Grand Island Resources Cross Mine (M1977-410) Amendment #2 Response to DRMS Comments to Adequacy Review No.4

Issue Date:
February 3, 2022

GIR 110(2) Amendment 2 – Revision 2.0
Grand Island Resources, LLC. Responses to DRMS Adequacy Review No. 4, dated January 25, 2022
February 3, 2002

EXHIBIT E - CROSS AND CARIBOU MINES MINING PLAN MAP: CROSS MINE AND CARIBOU MINE		
Project: CROSS AND CARIBOU MINE - AM 2 APPLICATION	Project No.: 21-1306	MAP
Location: NEDERLAND, COLORADO, USA	Date: FEB. 2022	02

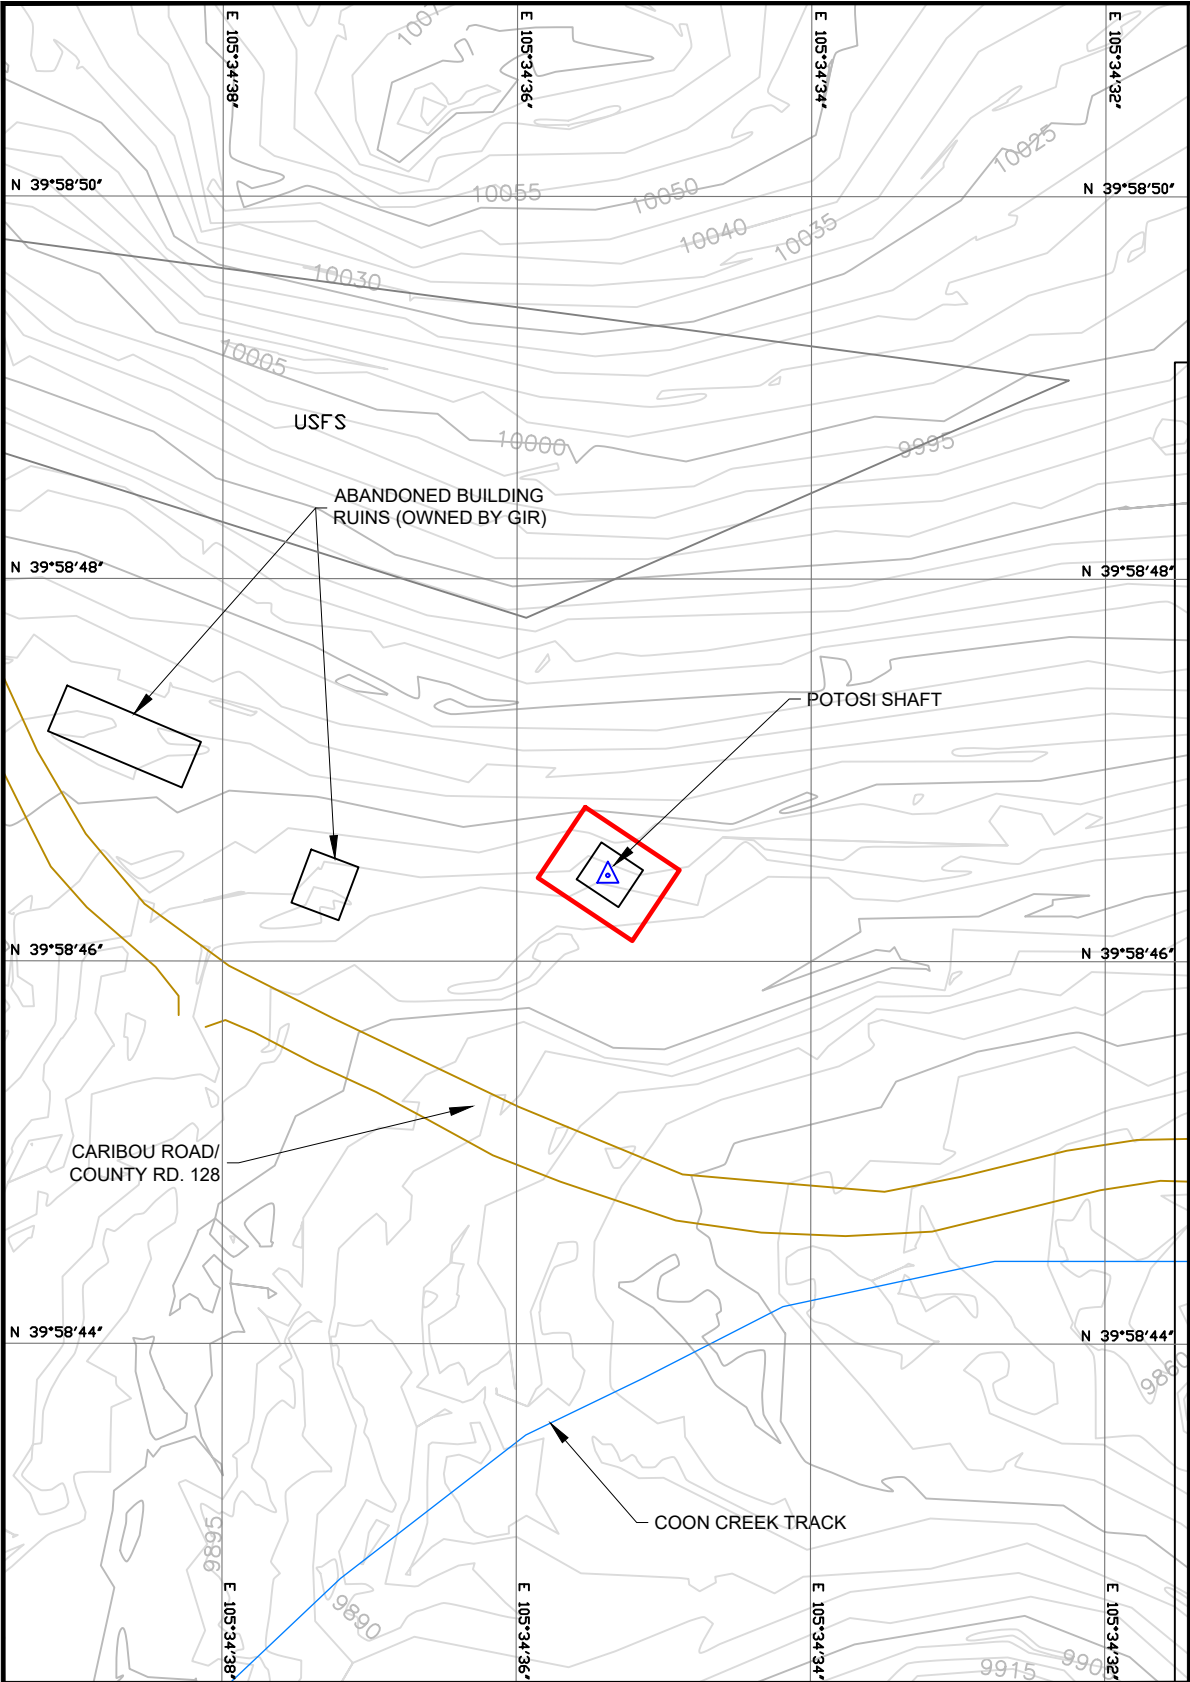
For Map 2, the Division has the following comments:

- a. Please include the names of all landowners within 200 feet of the proposed permit boundary, particularly the USFS, which owns land directly east of the proposed Cross-Caribou permit area (see enclosed screen capture of this parcel from Boulder County Assessor’s website).
- b. Please explain why the Cross Ventilation Shaft was removed from this map. This shaft was included on previously approved site maps.

- a. Corrected as requested on Exhibit E, Map 2. USFS was added as a property owner.*
- b. The Cross ventilation shaft was removed from site maps because the Cross ventilation shaft indicated on Maps 1, 3, 5, and 7, in GIR’s submittal dated November 23, 2021 might have been placed on previous references and maps for proposal purposes. This ventilation shaft, dating back to in Amendment 1 may have been associated with the previously proposed Cross Decline (which was not built). Upon review of the maps and physical surface site inspections of the area and underground location of ventilation systems, we are confident there are no ventilation shafts at that location. This feature has caused confusion because nearby, to the north-west, is a depression from the historic Cross shaft that was filled in back in 1930s. This historic shaft has no access to the mine nor any ability to ventilate the mine. We are labeling this depression as a historical shaft depression.*

EXHIBIT E - CROSS AND CARIBOU MINES MINING PLAN MAP: CARIBOU 300 AND POTOSI

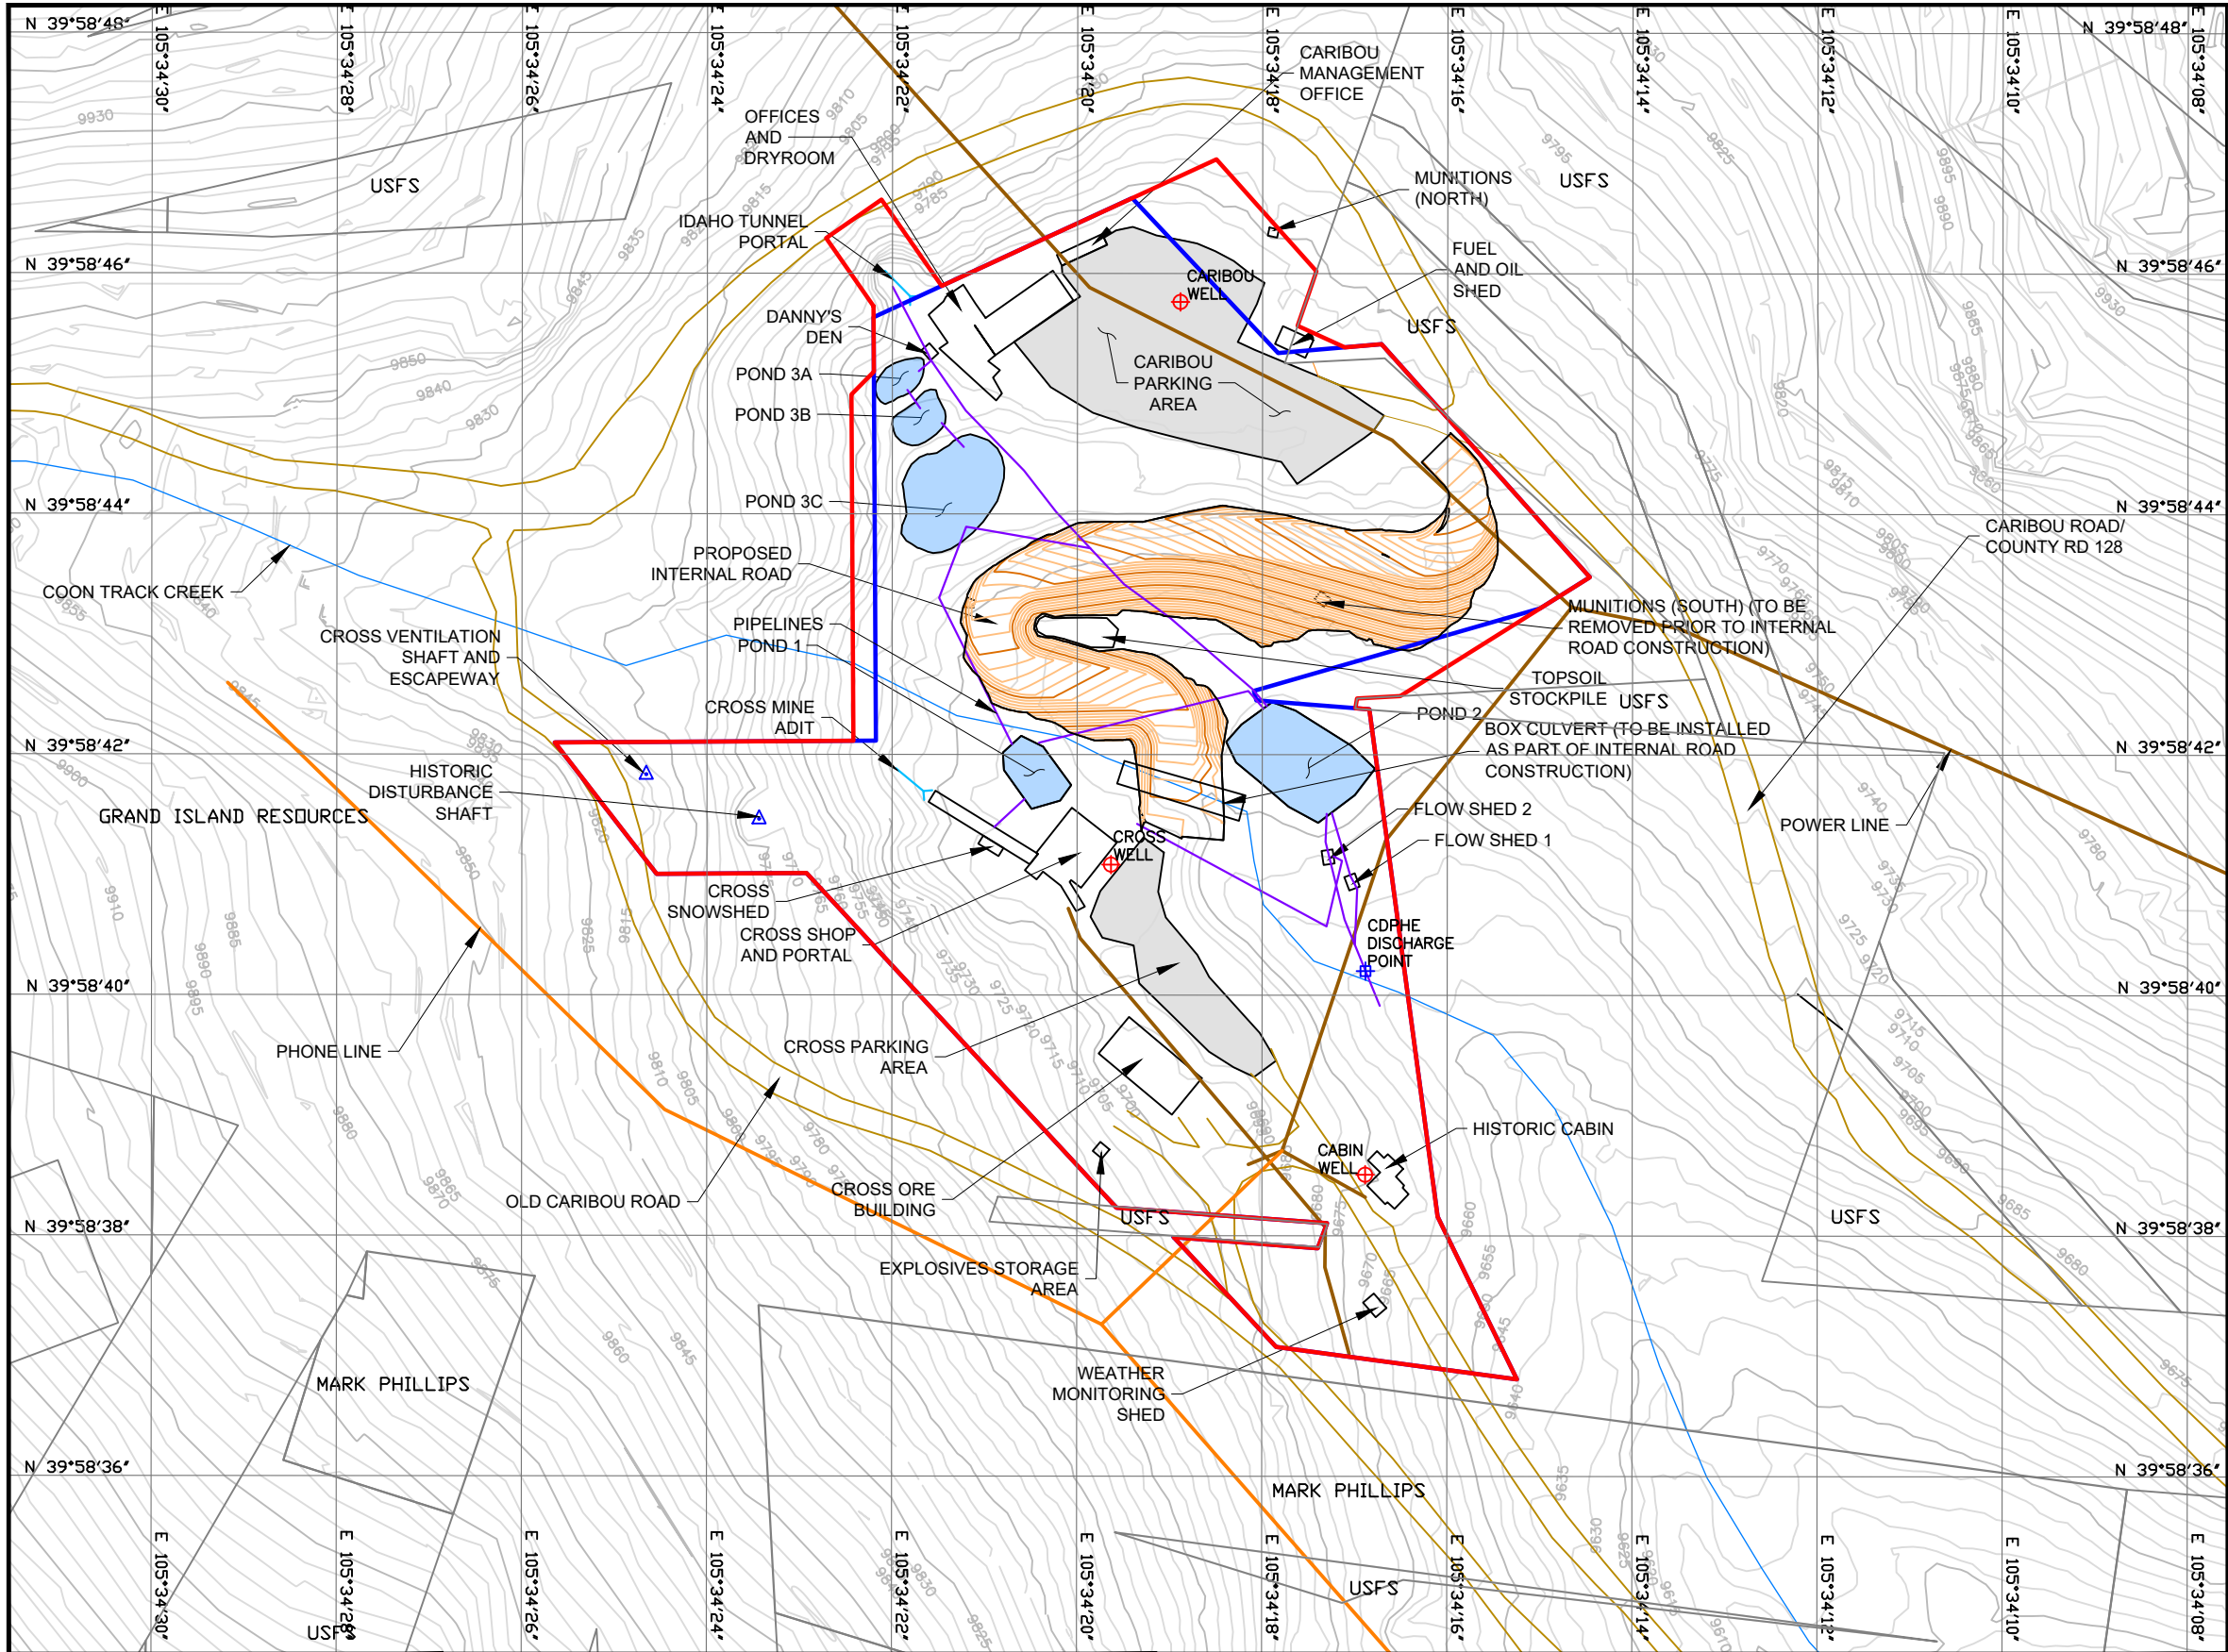
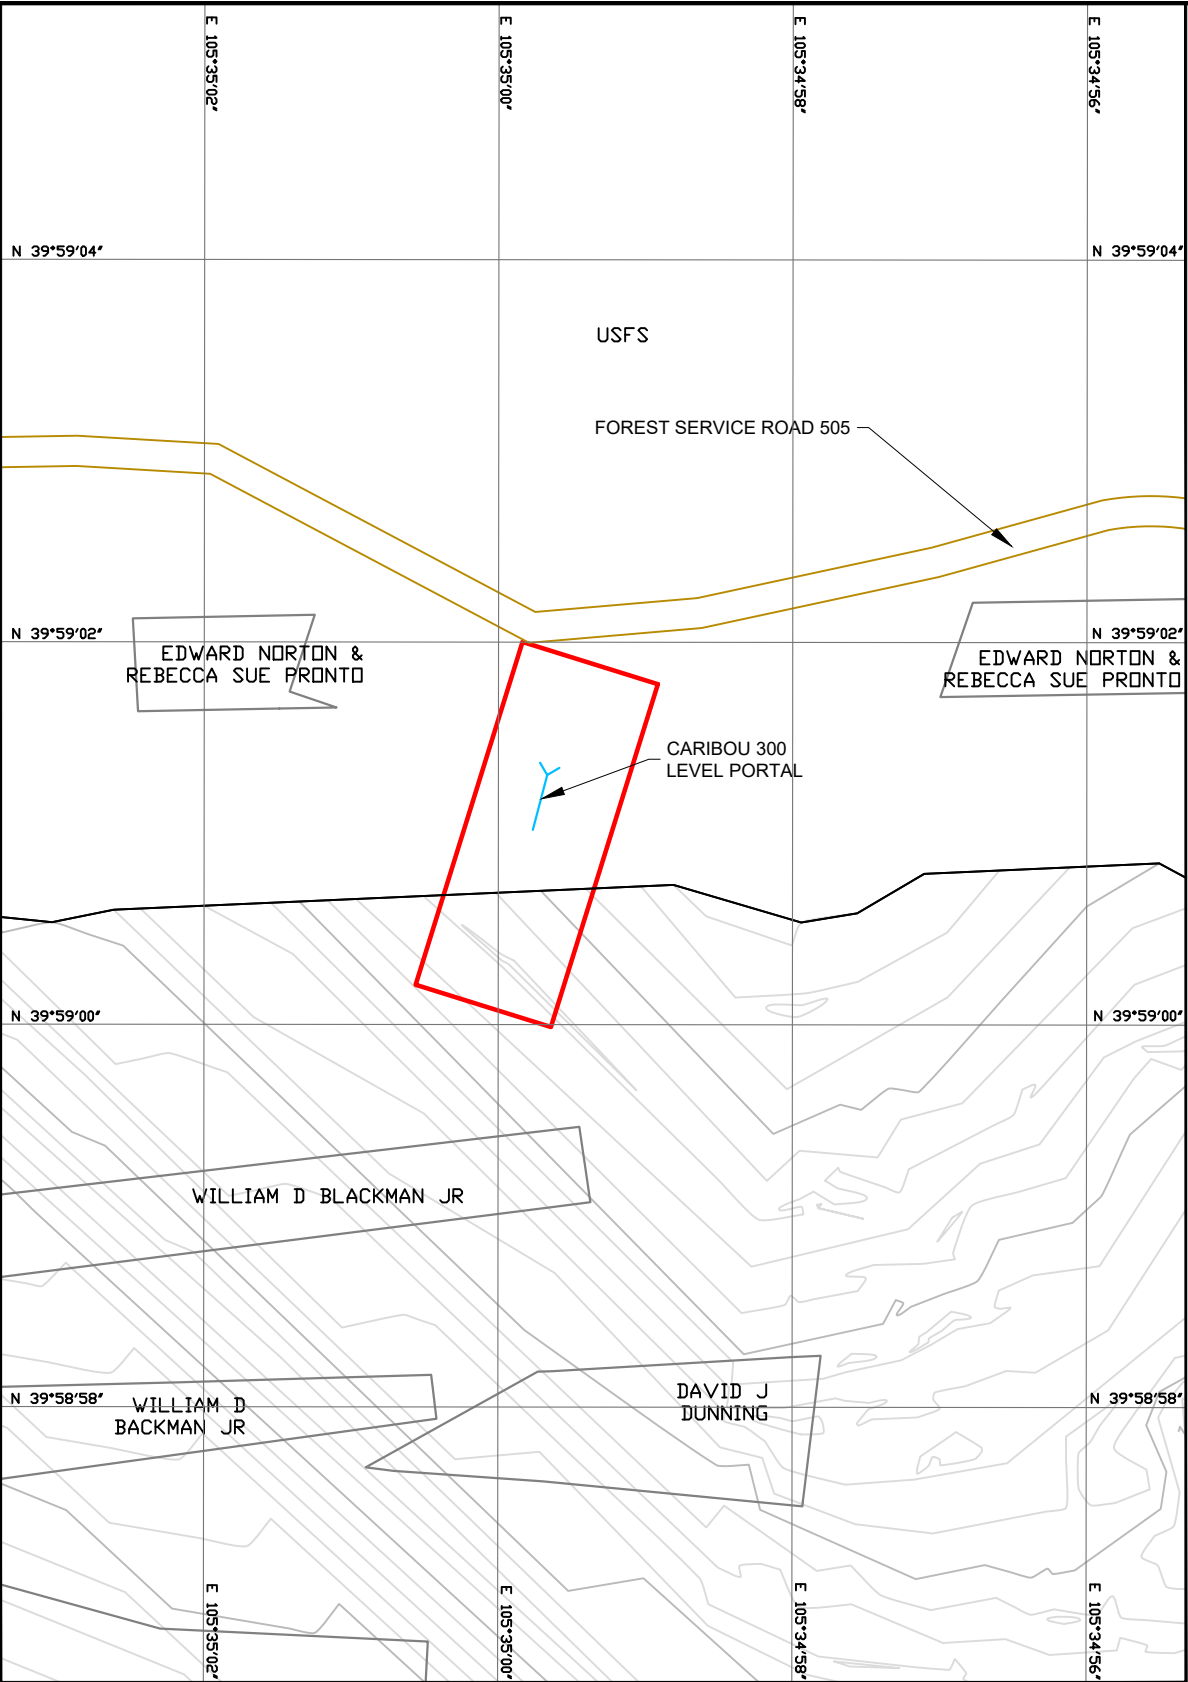
For Map 3, the Division has the following comments:

- a. Please ensure the names of all landowners within 200 feet of the proposed permit boundaries are correct. According to the Boulder County Assessor’s website, the parcel located west of the proposed Caribou 300 Level Portal permit area which is labeled “Aardvark Agencies Inc.” is actually owned by “Edward Norton and Rebecca Sue Pronto”. Additionally, the Assessor’s website shows the parcel located the closest to the southern boundary of the proposed Caribou 300 Level Portal permit area which is labeled “Robert P Fullerton” is actually owned by “William D. Backman Jr”. Screen captures of these parcels from the Boulder County Assessor’s website are enclosed.

Corrected as requested on Exhibit E, Map 3. The property owner was changed from Aardvark Agencies Inc. to Edward Norton and Rebecca Sue Pronto.
